STAFF REPORT
 July 7, 2015

AGENDA ITEMS: File No. 14004

Consideration of a Transit Oriented Development (TOD) preliminary master plan on 18.91 acres in the Eastside TOD district. The project site is located east of Gebhard Road and north of Beebe Road, and is identified on the Jackson County Assessor’s Map as 37S 2W 02 Tax Lots 2700 and 2701. The project site is within the LMR—Low Mix Residential (2.69 acres) and MMR—Medium Mix Residential (16.22 acres) zoning districts. **Applicant:** People’s Bank of Commerce; **Agent:** Tony Weller, CES|NW.

EXHIBIT "2"

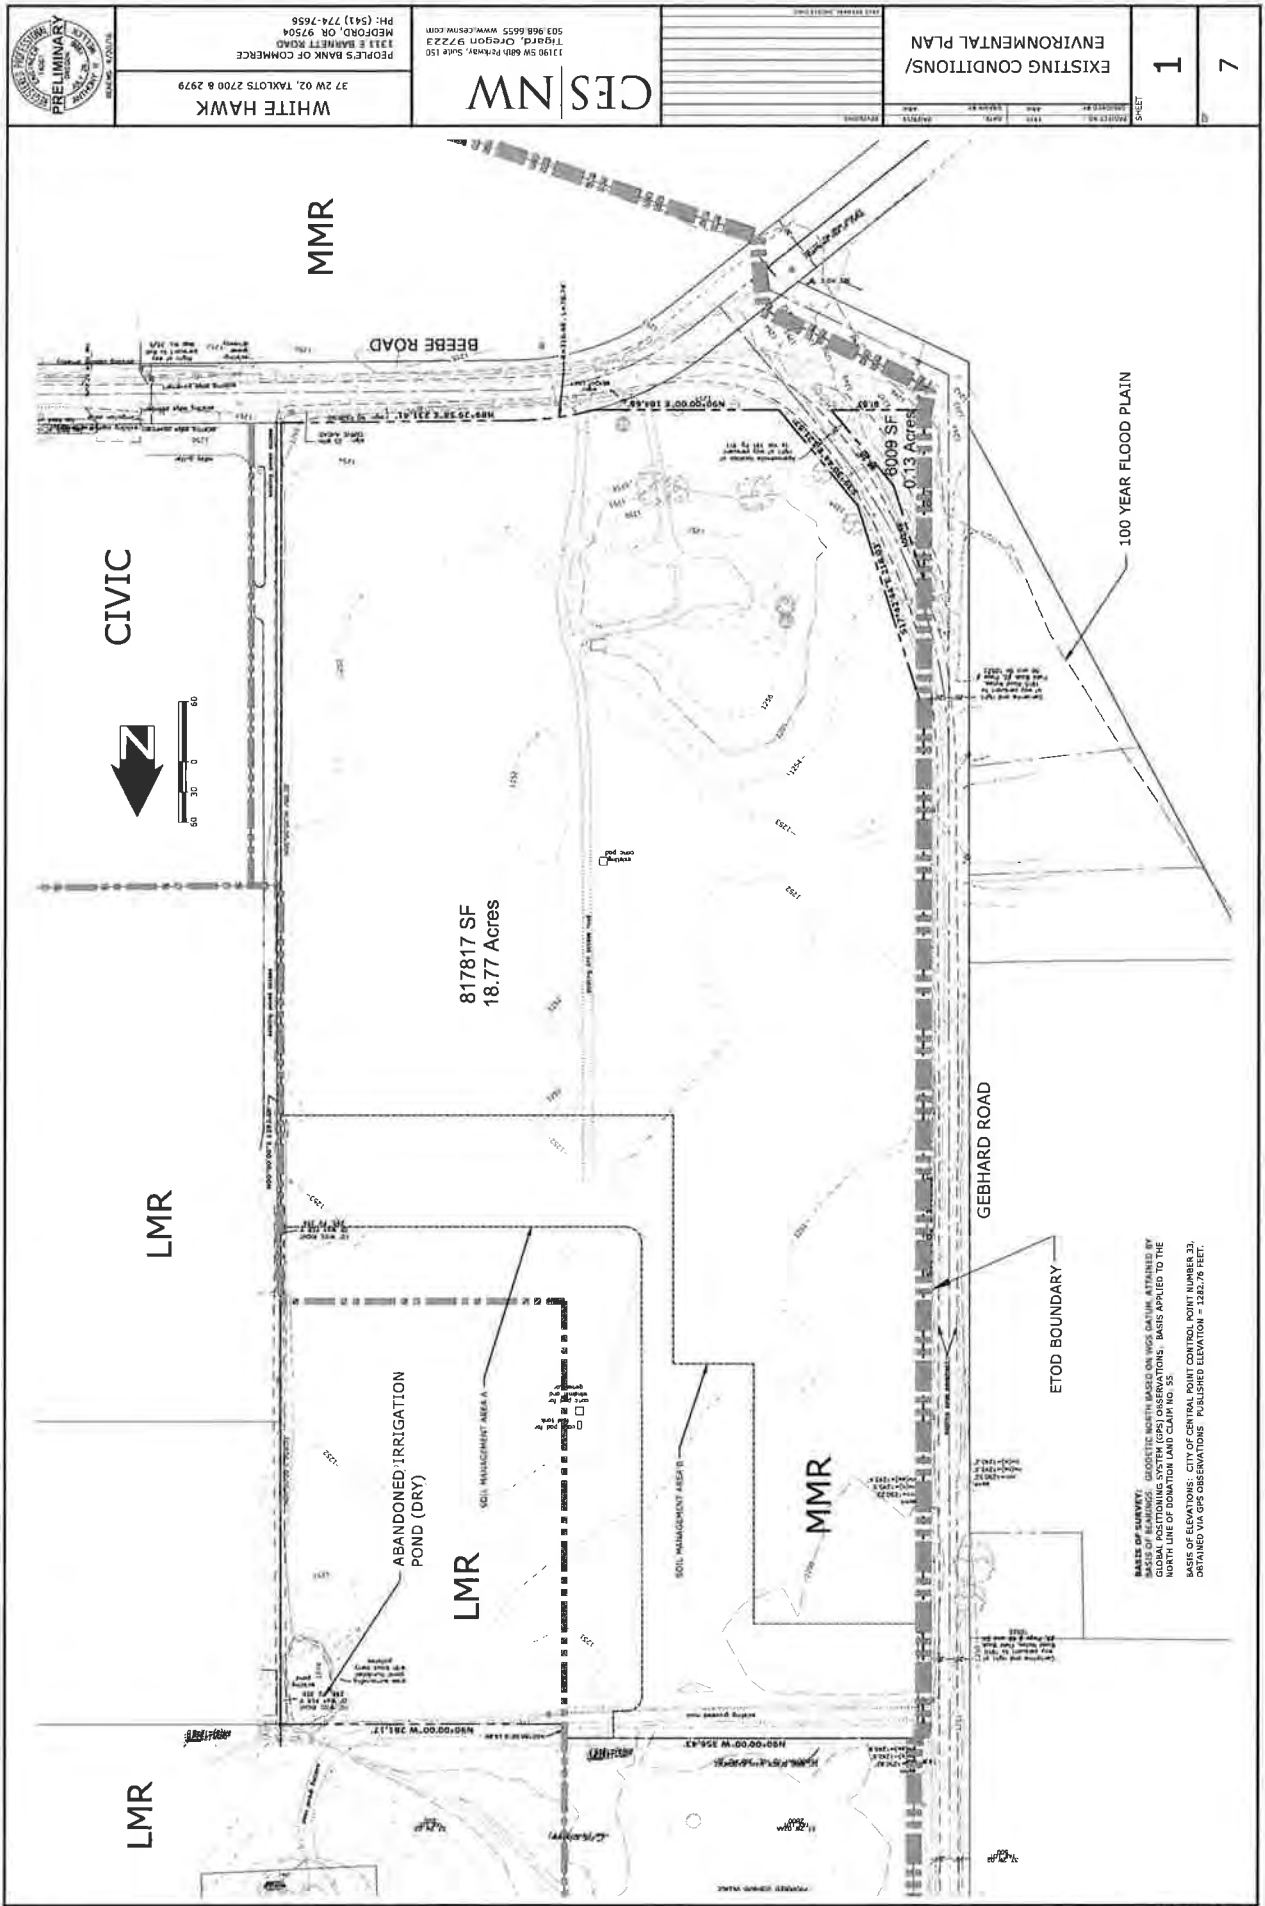
1. **Contaminated Soils, Proposed Public Park Site.** The Preliminary Master Plan noted the presence of soil contamination in the northeast quadrant of the project site. The extent of the contamination was not made available to the City until a draft Independent Clean-up Report ("Report") was, at the City's request, made available on June 17, 2015. It was the Report's finding that within the northeast quadrant of the project site, which includes the proposed public park site, there was evidence of arsenic and DDT contamination in excess of the State's acceptable risk level. The Report addressed mitigation options that included the Applicant's preferred alternative, including:

At this time, based on the limited information regarding mitigation planning, the cost of mitigation and the long-term maintenance commitment required for the proposed park site, the City is not in a position to commit to acceptance of the proposed park site for public use. Further, the timing and cost of the soil mitigation must be coordinated with the proposed phasing plan demonstrating that soil mitigation is feasible and the cost of remediation is reasonably distributed across the proposed project phases.

Resolution: Based on insufficient information on the extent of soil remediation and therefore the uncertainty of the City's willingness to accept the park site at this time, it is Staff's recommendation that the Planning Commission continue the public hearing on the Preliminary Master Plan to a date specific allowing the applicant adequate time to either:

- A. Provide an updated Environmental Plan (Exhibit 2) that addresses soil remediation, specifically addressing the type of mitigation proposed; including mitigation costs, mitigation timing as part of the overall development project, long-term maintenance requirements and costs, and the deed restriction language and area/lots subject to the deed restriction. The revised Environmental Plan must be coordinated with and acceptable to the City; or

1. To justify use of the proposed park as a public park, the Applicant shall amend the Environmental Plan (Exhibit 2) to provide a soil remediation plan coordinated with and acceptable to the City. Submittal of this information may be deferred as a condition of Preliminary Master Plan approval if the applicant elects to propose alternative use for the site. At a minimum the Environmental Plan and Preliminary Master Plan narrative (Attachment "B") shall include the following:
 - a. A soil remediation plan addressing mitigation measures, timing and cost;
 - b. Long-term maintenance requirements, including timing and costs; and,
 - c. Language for the required deed restriction and area/lots subject to the deed restriction.

3. The Environmental Plan narrative (Attachment "B") shall be amended to include the proposed shallow well mitigation measures, per the APEX report (Appendix "B"). Well data shall be provided as part of the Environmental Plan (Exhibit 2).

EXHIBIT "4"

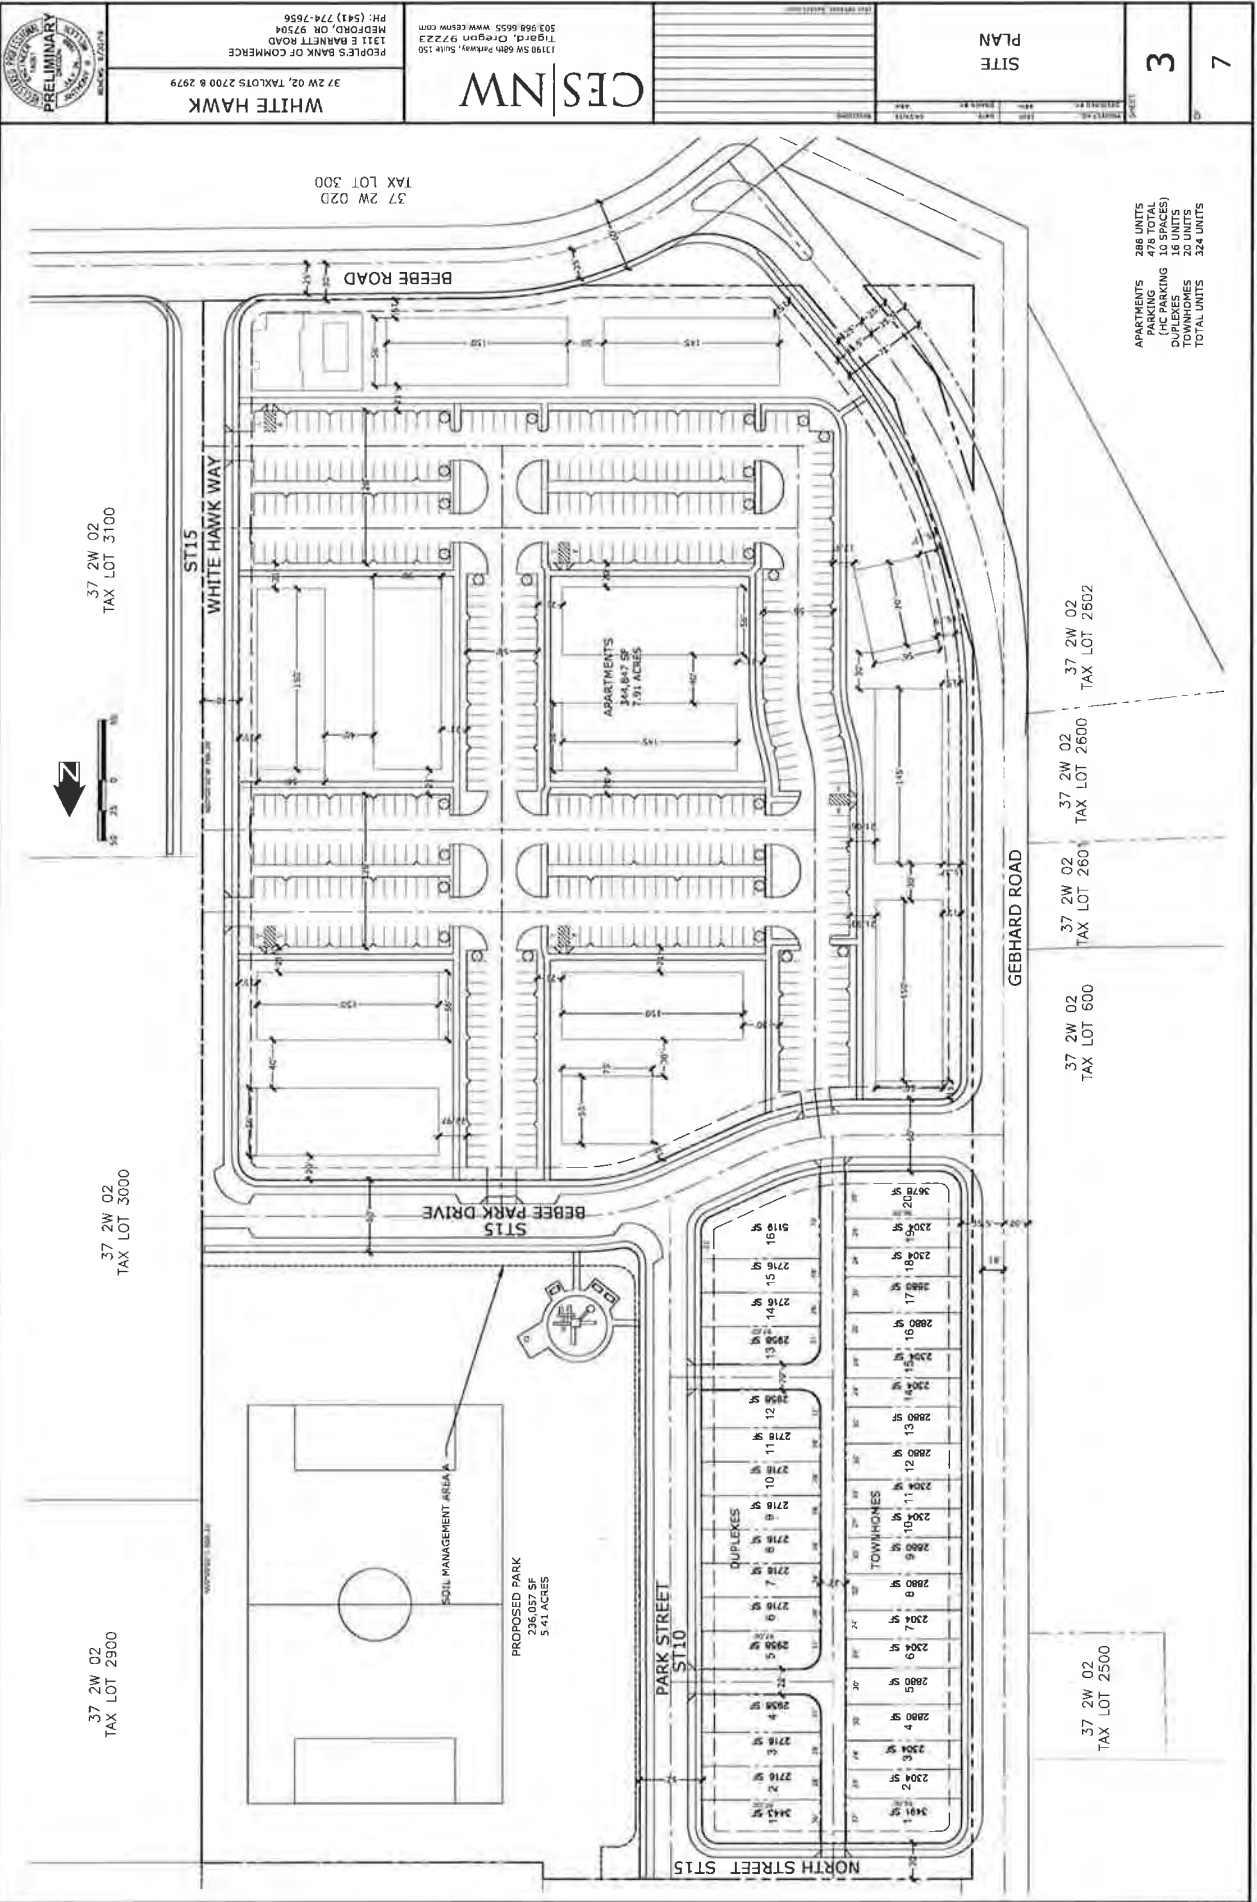
4. **Phasing Plan: Internal Street Network.** The Phasing Plan needs to clearly delineate the location and timing of development phases in relation to street improvements, including soil remediation, park development and transfer, and right-of-way dedication to the City. The Applicant's Findings provide for up to four (4) development phases, including two phases for the apartments, and two phases for the duplexes and townhouses. The location of each phase and the associated public improvements needs to be coordinated with the transportation plan (Exhibit 7), site plan (Exhibit 4), and partition plat (File No. 14016). Further instruction in the master plan narrative (Attachment "B") will need to describe how the public improvements will be staged as part of the tentative partition plat process.

Resolution: As a condition of the Preliminary Master Plan, the applicant will be required to amend the Transportation and Circulation Plan (Exhibit 7) and Site Plan (Exhibit 4), including the narrative (Attachment "B"), to delineate the phases of development and associated public and private street improvements. The narrative needs to address how the street improvements will be made as part of the land division process.

EXHIBIT "7"

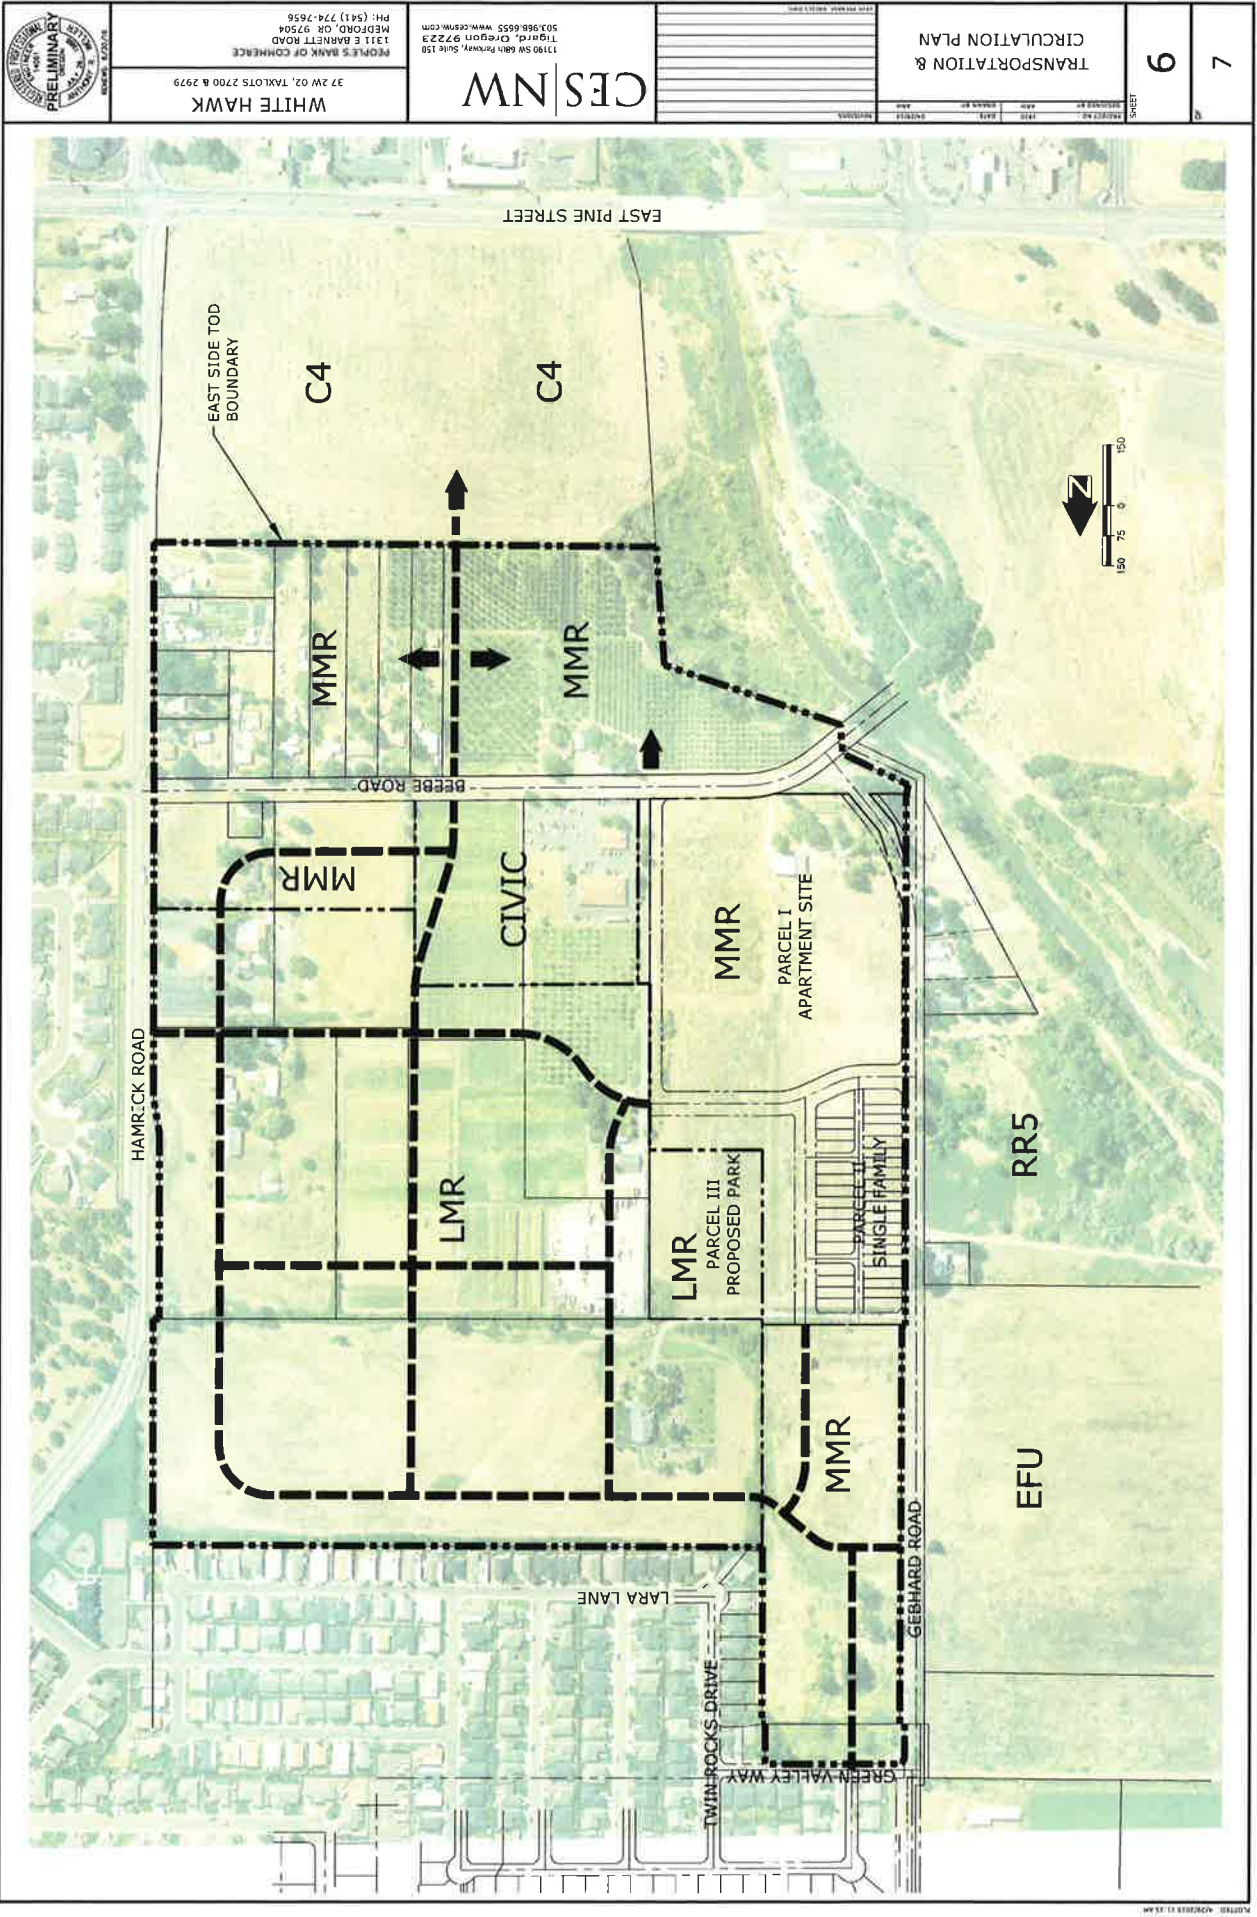
2. **Transportation System Plan (TSP).** The applicant's findings do not address the City's TSP, particularly as it pertains to the southerly extension of Gebhard Road. The applicant has prepared a plan addressing neighborhood circulation (Exhibit 7), but neither the proposed neighborhood circulation plan, nor the Preliminary Master Plan narrative address the TSP and the future extension of Gebhard Road. The City is currently preparing a study identifying a preferred route (Agenda Item VI-1). It is the City's objective to have a general consensus on the preferred Gebhard Road route based on discussions on Agenda Item VI-1 at the July 7, 2015 Planning Commission.

2. The Transportation and Circulation Plan (Exhibit 7) and Preliminary Master Plan Narrative (Attachment "B") shall be amended to address the Transportation System Plan (TSP) relative to the southerly extension of Gebhard Road per the preferred Gebhard Road route identified by the Planning Commission at the July 7, 2015 meeting, or workable alternative(s), including the extent and timing of improvements.

4. A Development Phasing Plan for each anticipated phase of development, including location and timing of associated public and private street improvements relative to the land division process, shall be set forth in the Preliminary Master Plan narrative, and illustrated on the Site Plan (Exhibit 4), the Transportation and Circulation Plan (Exhibit 7) and tentative plat (File No. 14016).
